TENDER ADDENDUM

Project:	UHN Interventional Fluoroscopy Replacement University Hospital of Northern British Columbia 1475 Edmonton Street, Prince George, BC V2M 1S2	Tender Addendum #:	02
		DCTYA Project #:	2009
		NHA Project #:	N662050005
		Issued By:	Douglas Cheung
To:	All Bidders	Issue Date:	Feb 26, 2021
Copies To:	Leah Joseph / Northern Health Authority

STRUCTURAL ADDENDUM No. 2

Project: UHN Fluoroscopy Replacement **File:** 11815
Architect: DCYT Architecture, Douglas Cheung **Date:** February 26, 2021

**PHASE 1
A2.06**

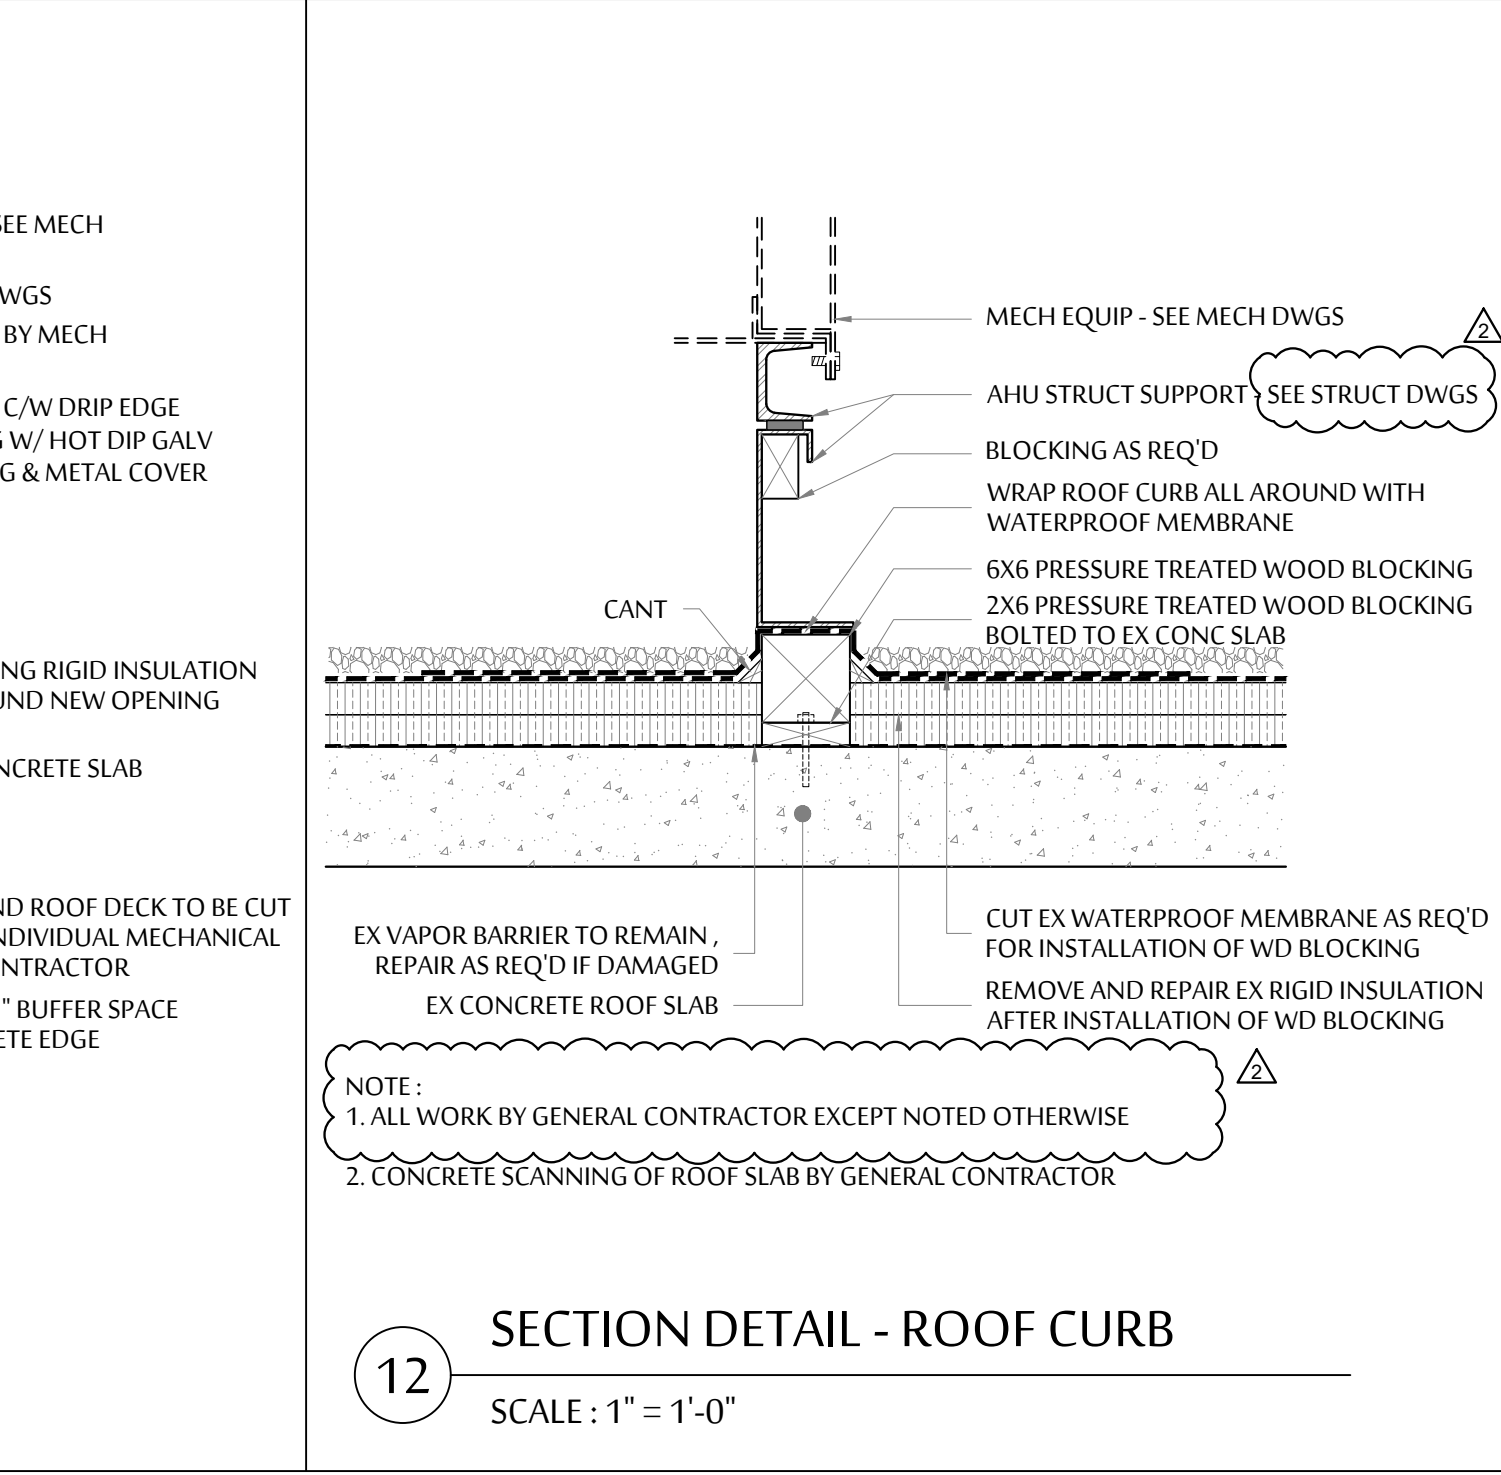
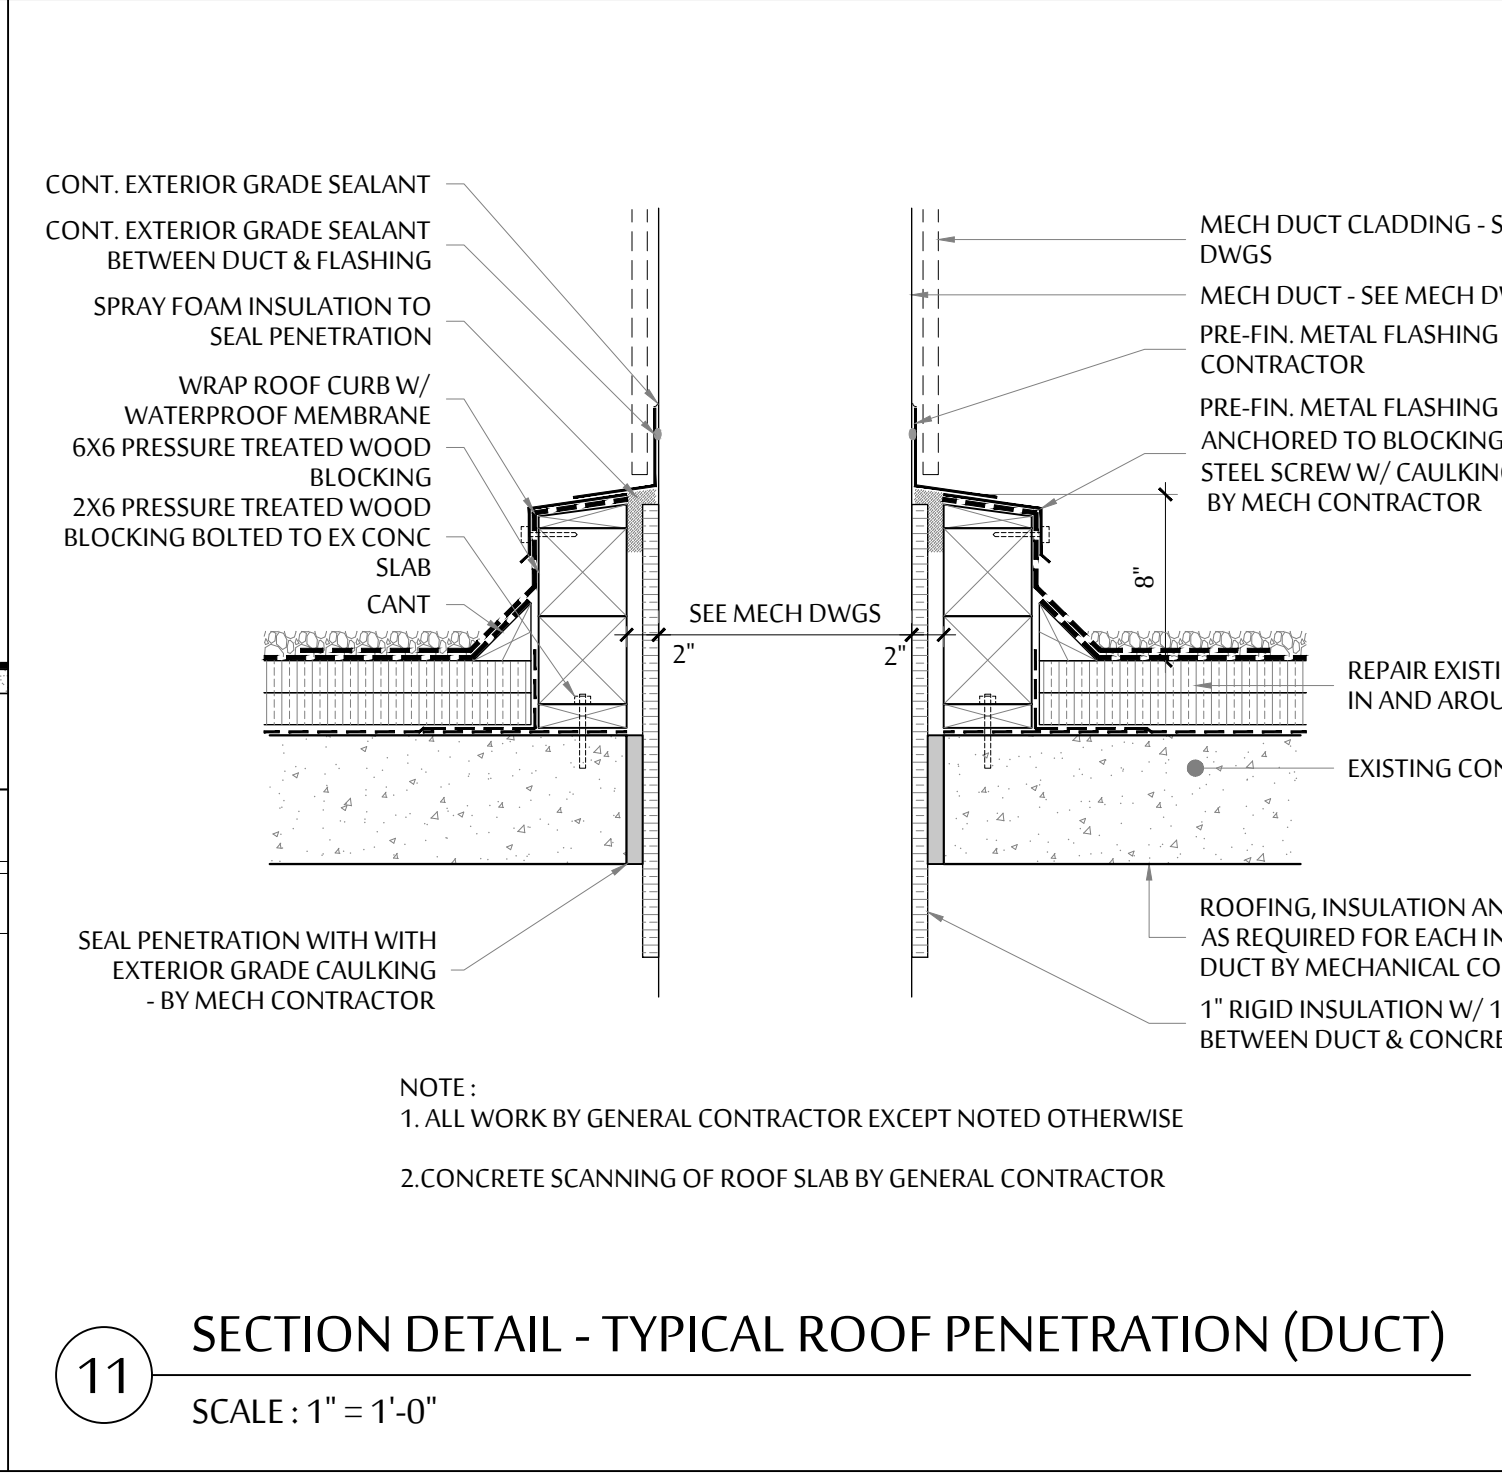
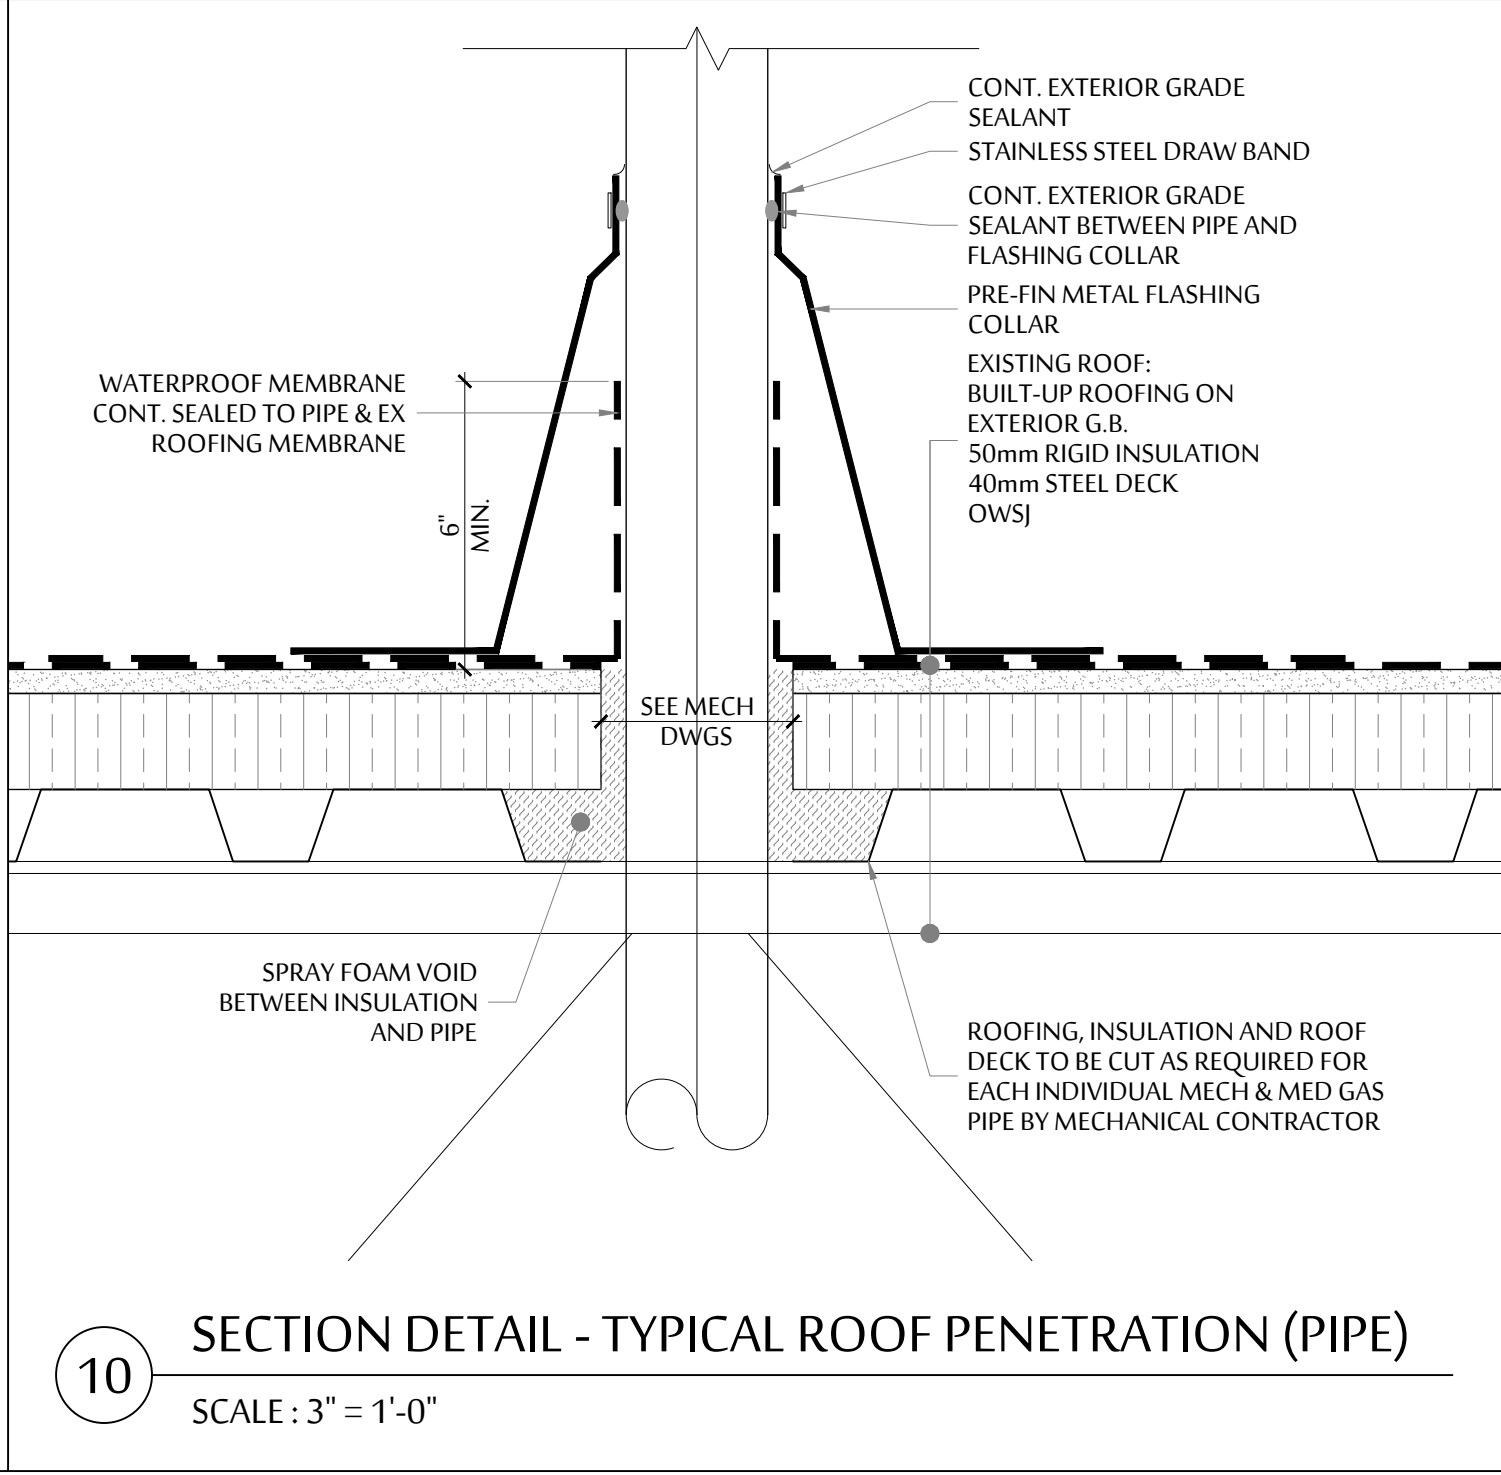
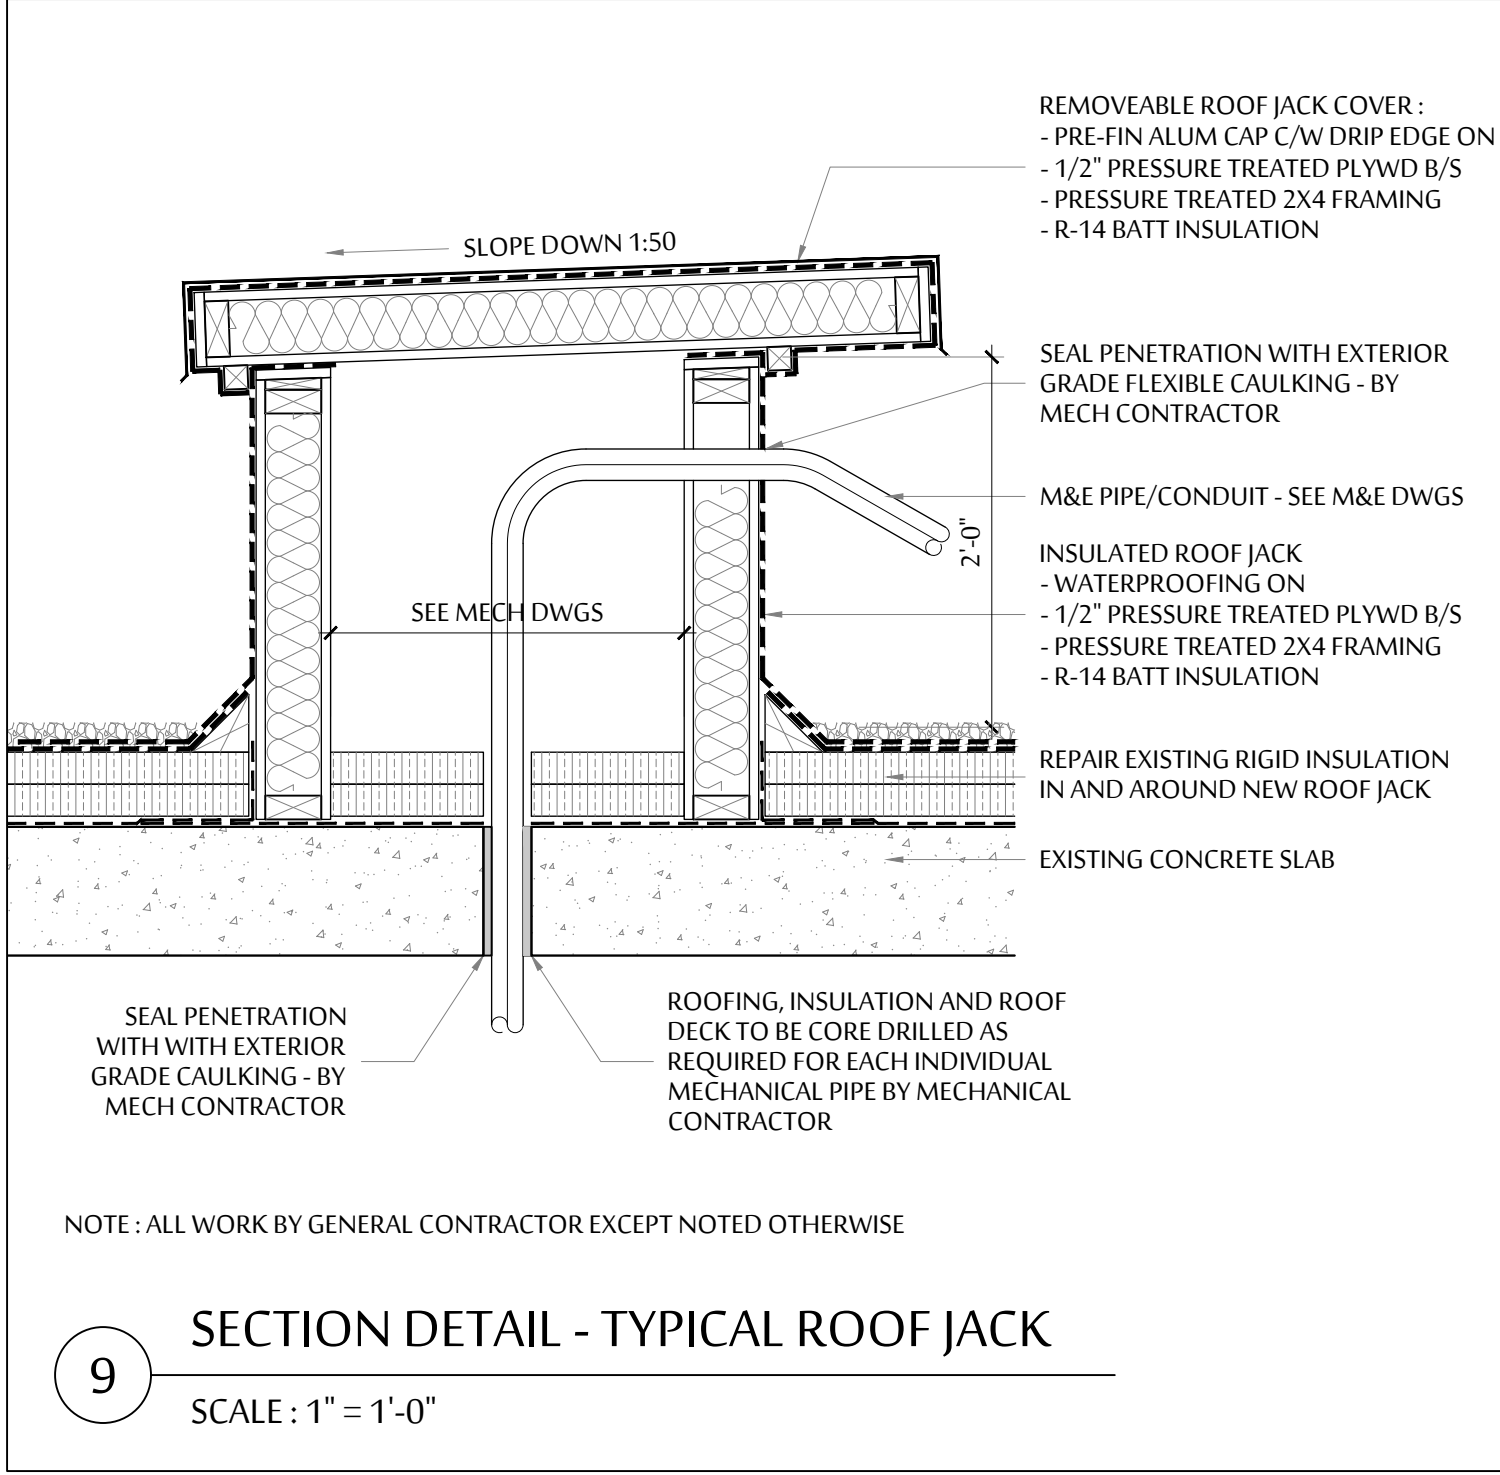
- 5.1. See attached Dwg A2.06 – Roof Plan, for revisions to roof plan and roof construction key notes.
- 5.2. See attached Dwg A5.03 – Typical Details, for detail revisions.
- 5.3. See attached ADD2-A02 – Part of Dwg A5.02, for revisions to finishes and fixtures schedule.
